Project Title: Chick-fil-A at Wyoming Boulevard Building Permit #: _____ City Drainage #: _____

Re: **Chick-fil-A**
2274 Wyoming Blvd. NE
Grading and Drainage Plan
Engineers Stamp Date 12/15/14 (H20-D003C)

Merrick & Company has reviewed the comments received on February 19, 2015 regarding the proposed Chick-fil-A located at 2274 Wyoming Blvd. NE. The following summarizes Merrick's response to the comments provided by the City of Albuquerque.

C-0.0

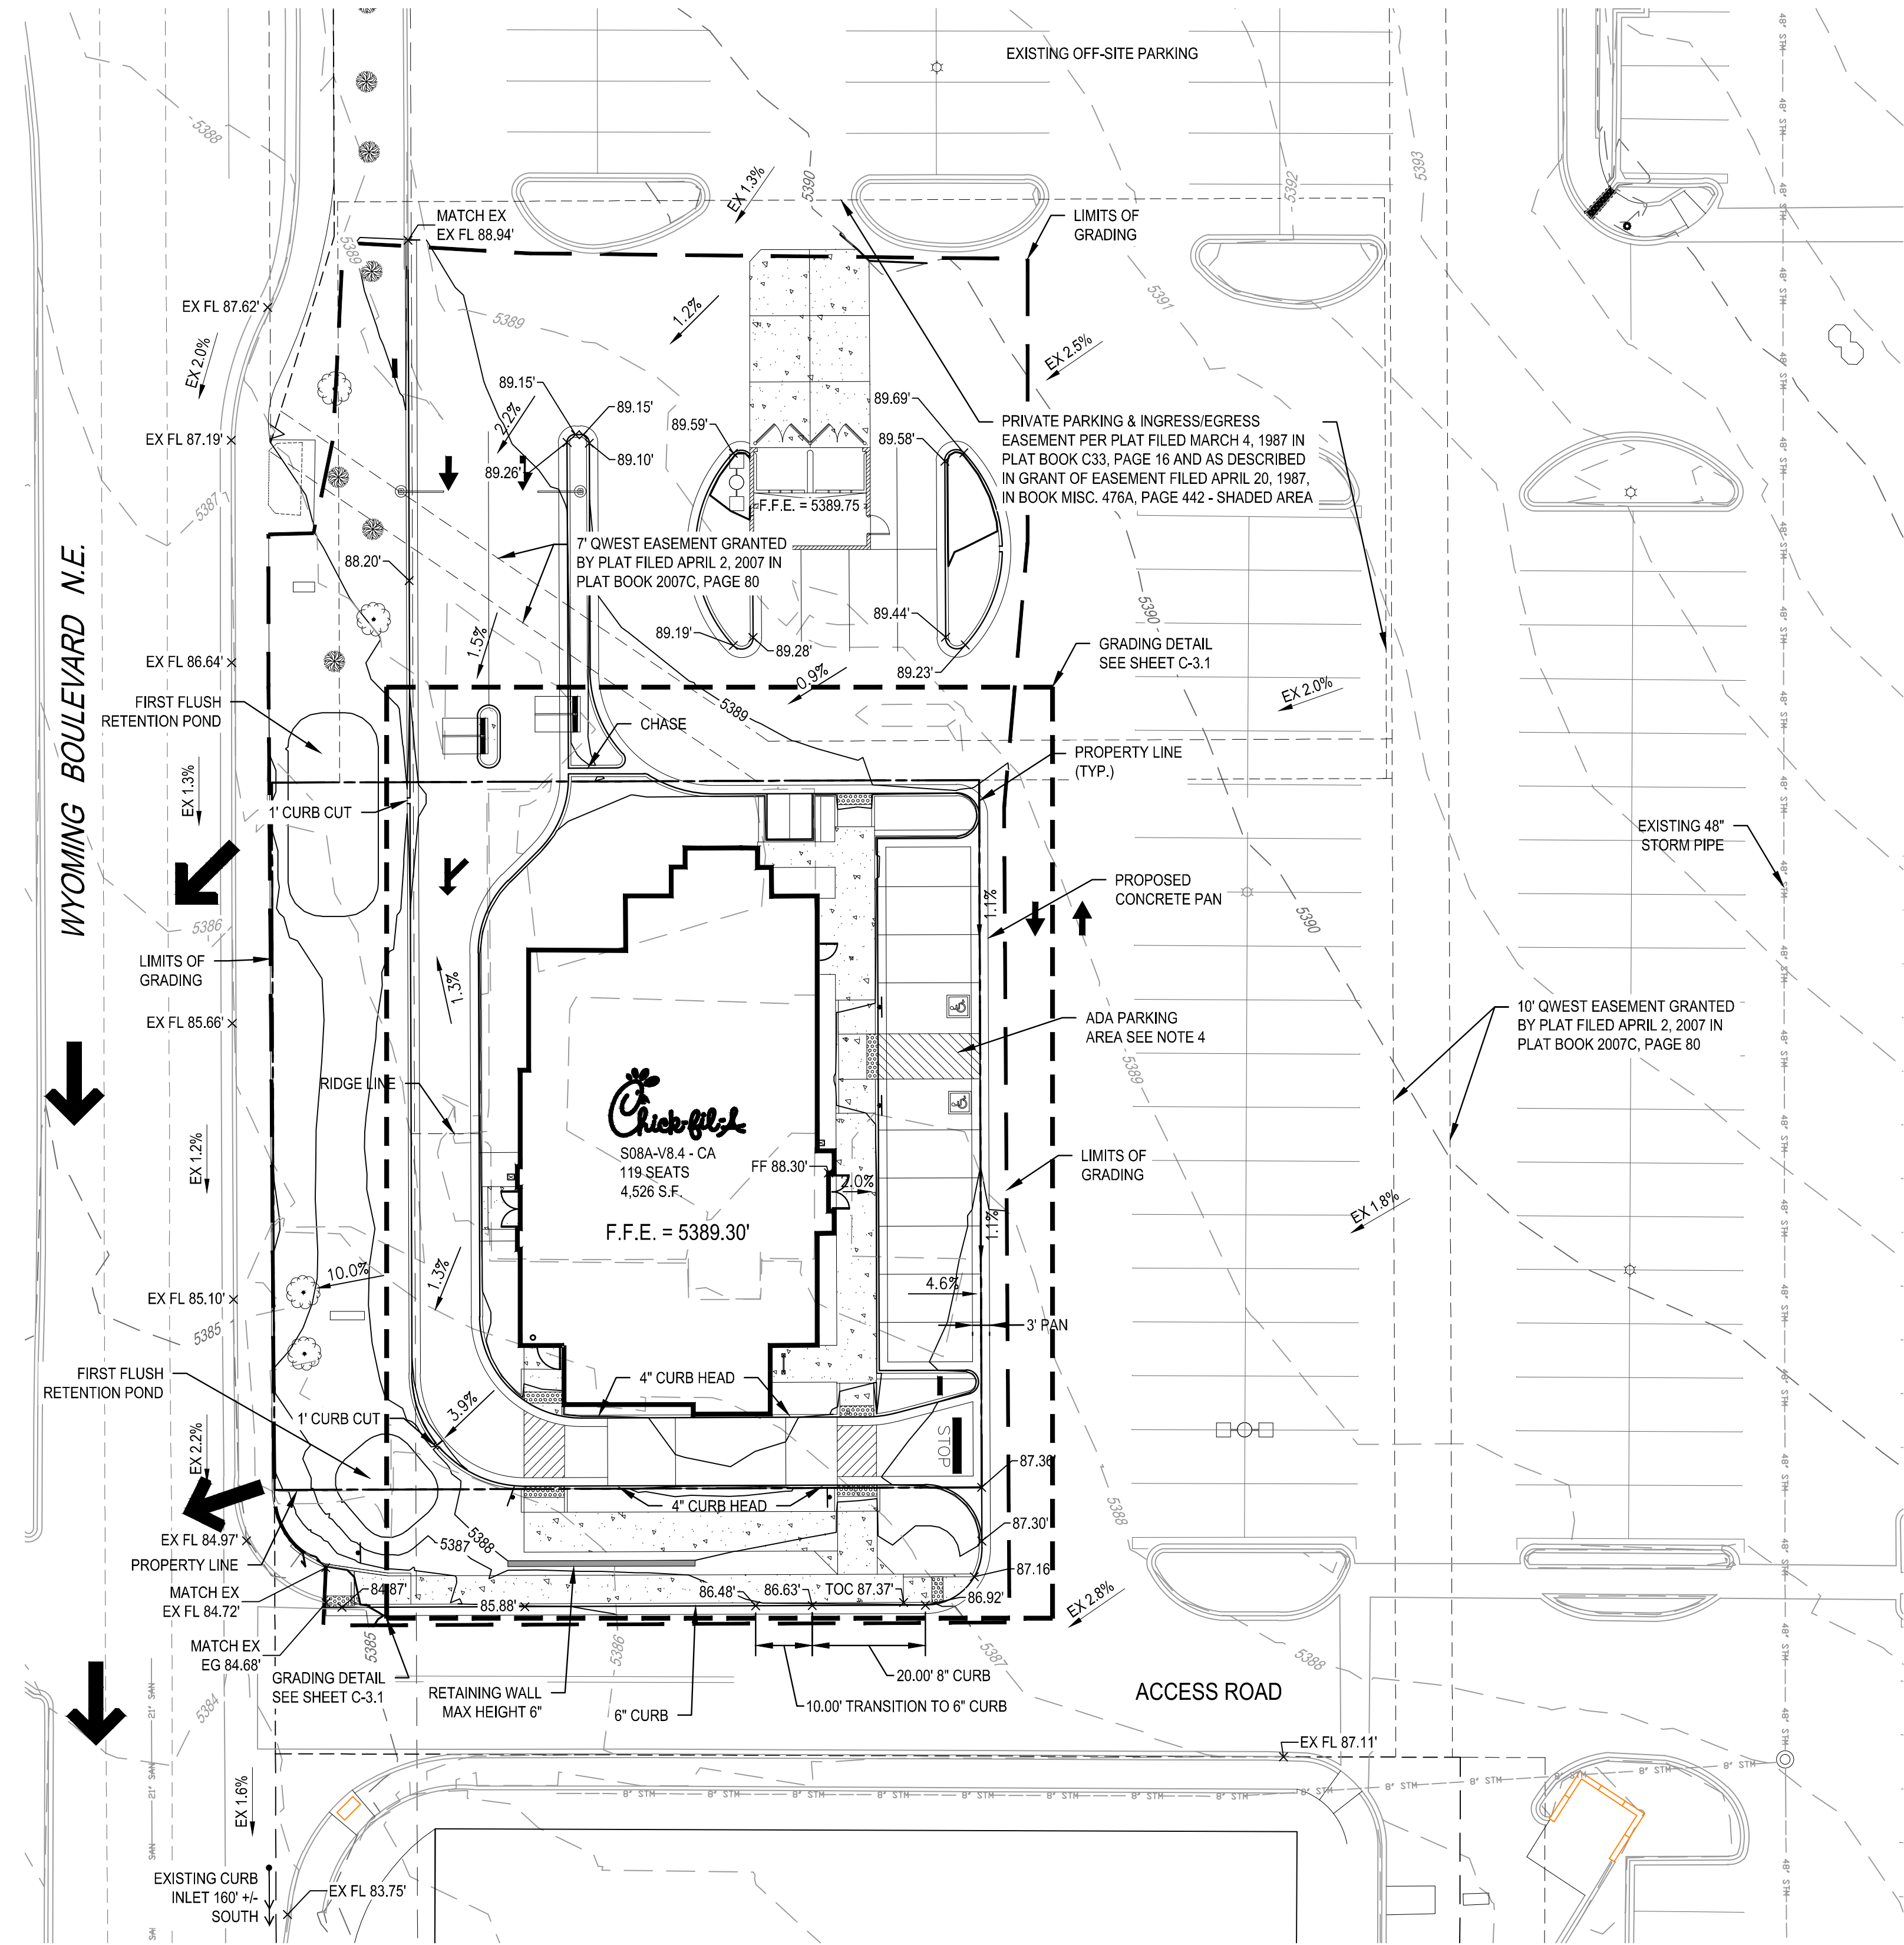
- Provide the vicinity map. Also provide the FIRMette or mention the flood zone and map page.

- Provide the legal description on the G&D plan.

Response: The vicinity map and FIRMette have been provided.

Response: The legal description on the G&D plan has been provided.

C-3.0

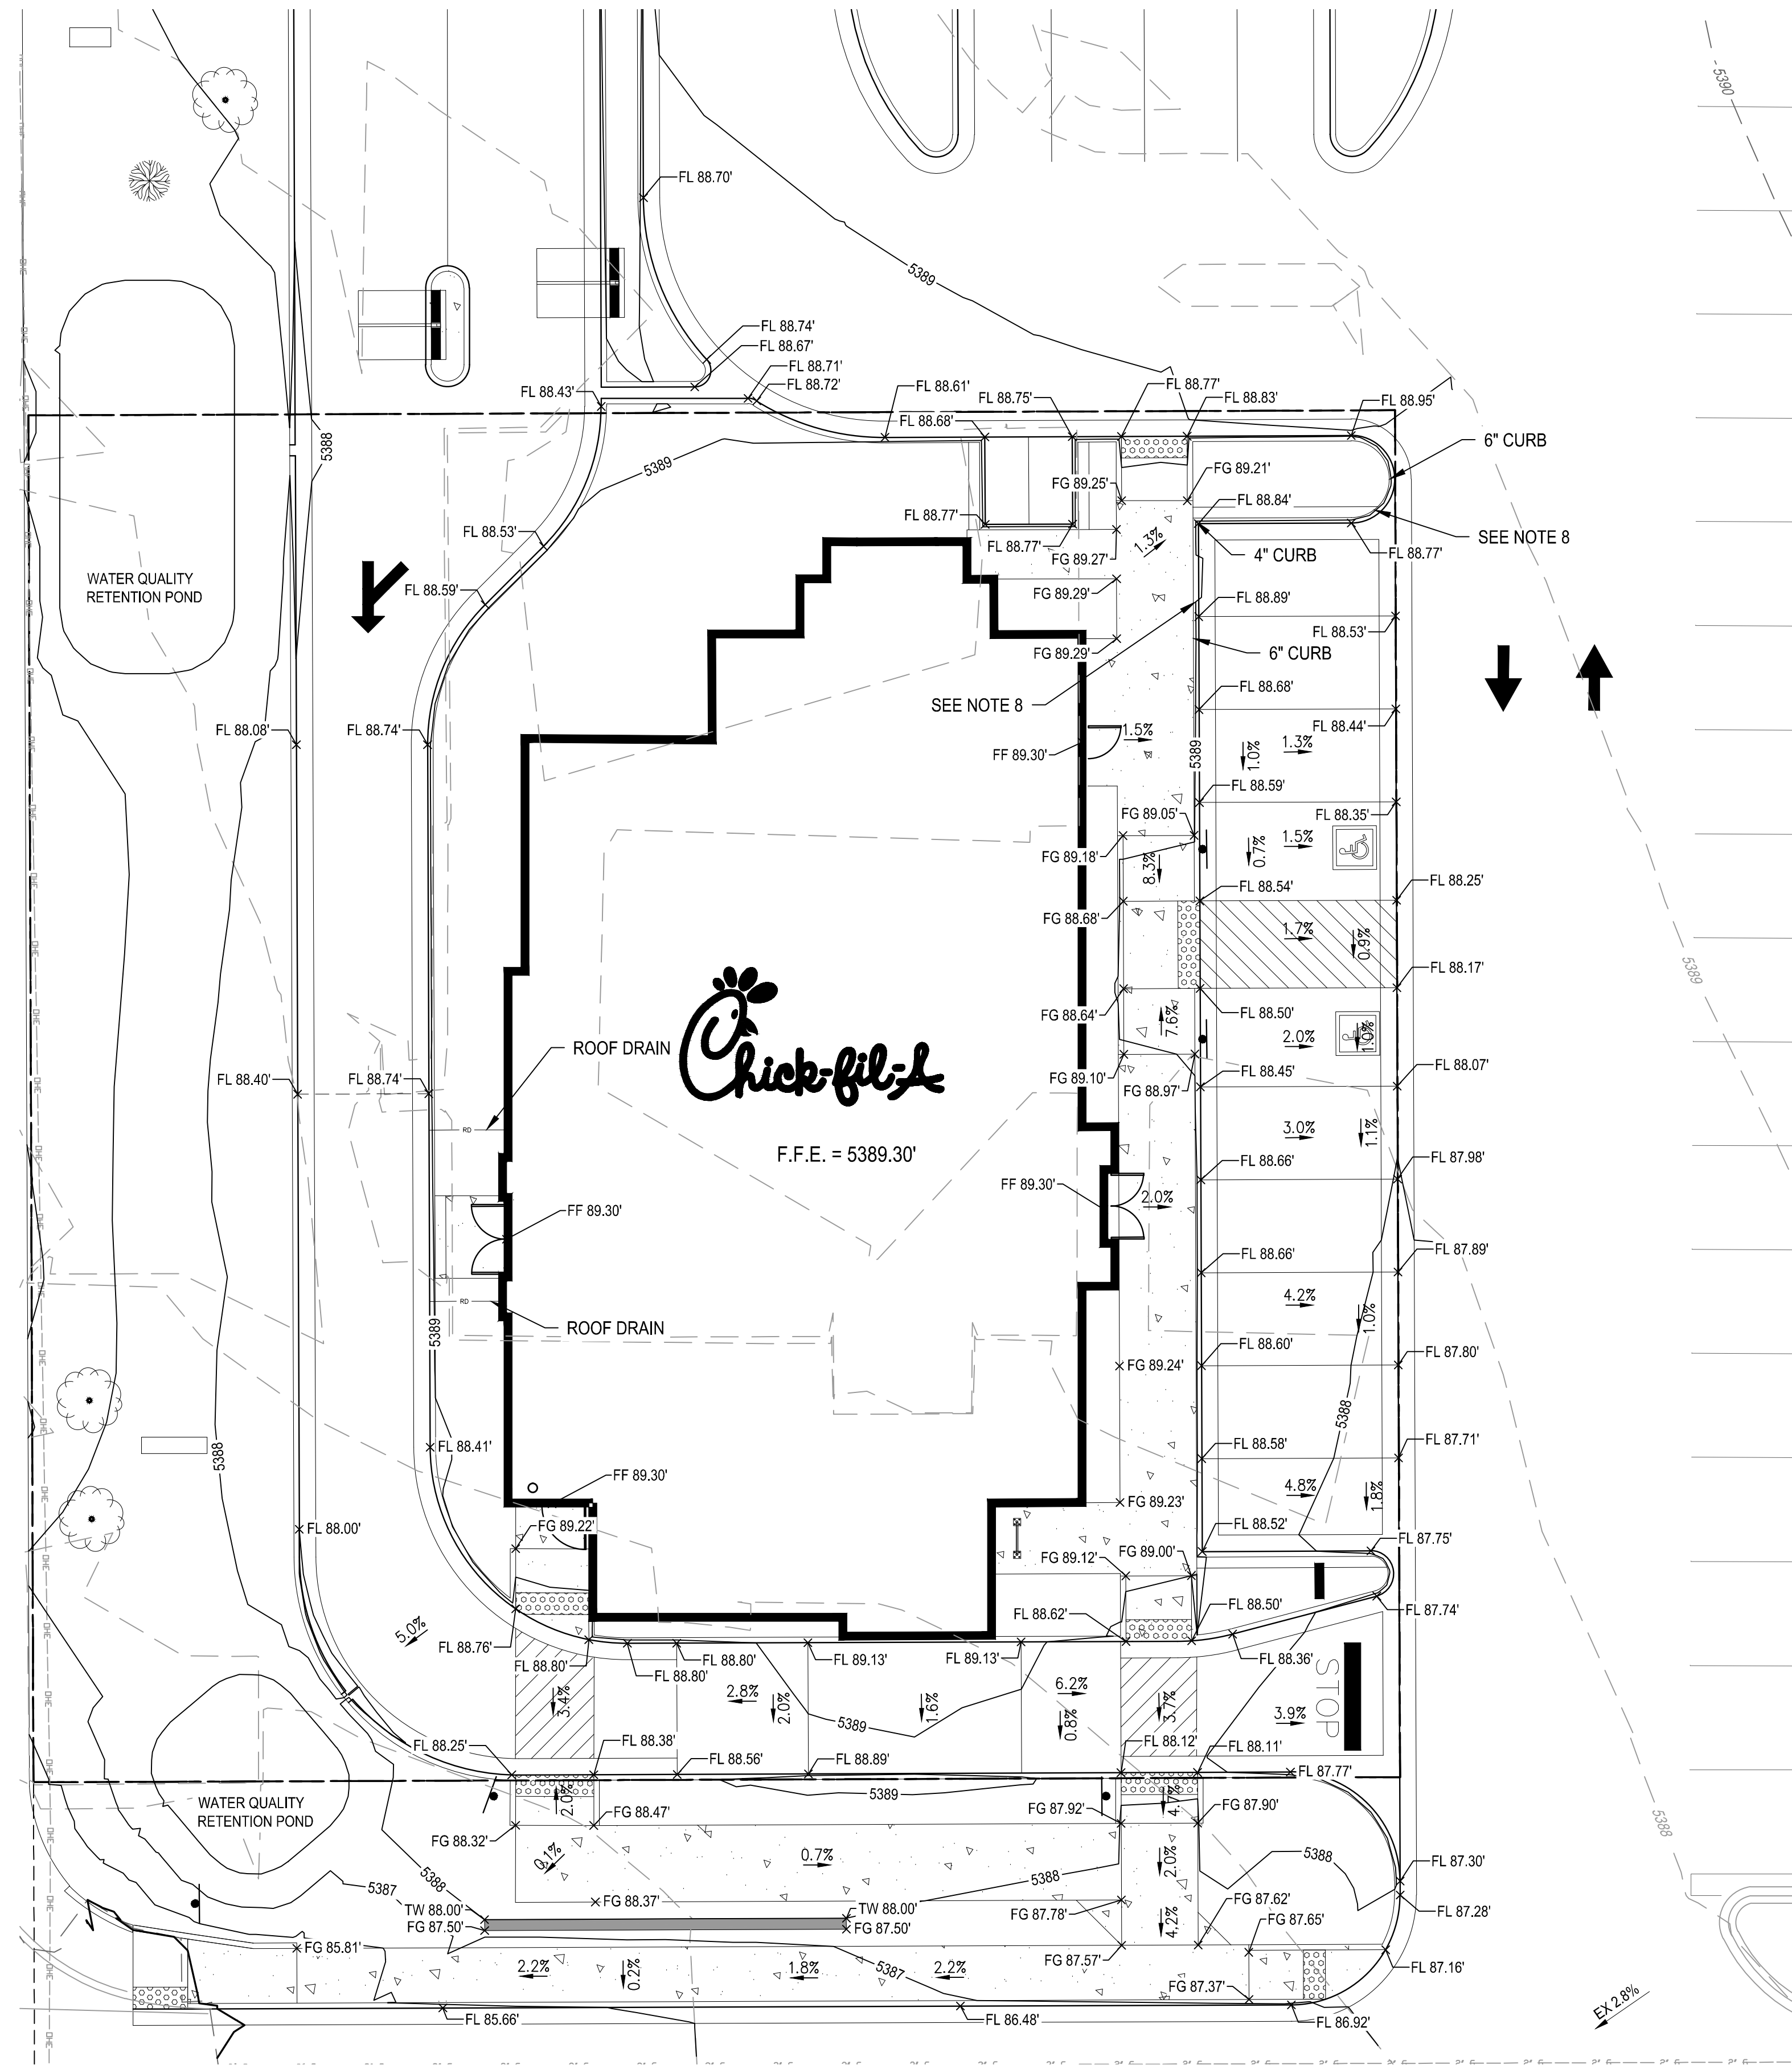
- Mention of the first flush per EPA standards is required. The amount required is .34" times the impervious area. We believe there is enough landscape area to accomplish this requirement.

- Depress all landscape areas which are no closer than 10 feet from the building.

Response: The first flush has been mentioned and retention ponds have been sized accordingly.

Response: Landscape islands have not been depressed because bio-retention ponds have been provided to accommodate the first flush requirements.

Sheet
DN-1.0

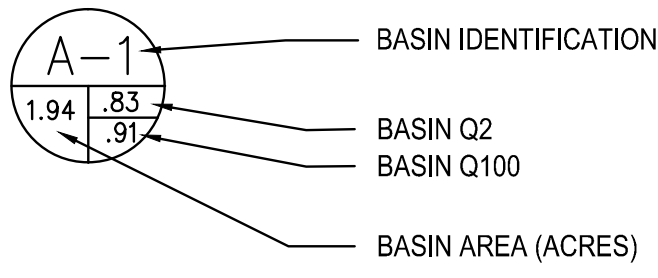
- Provide a basin map.

- Show the roof flows.

Response: A basin map has been provided.

Response: Roof flows are now shown on the developed drainage map.
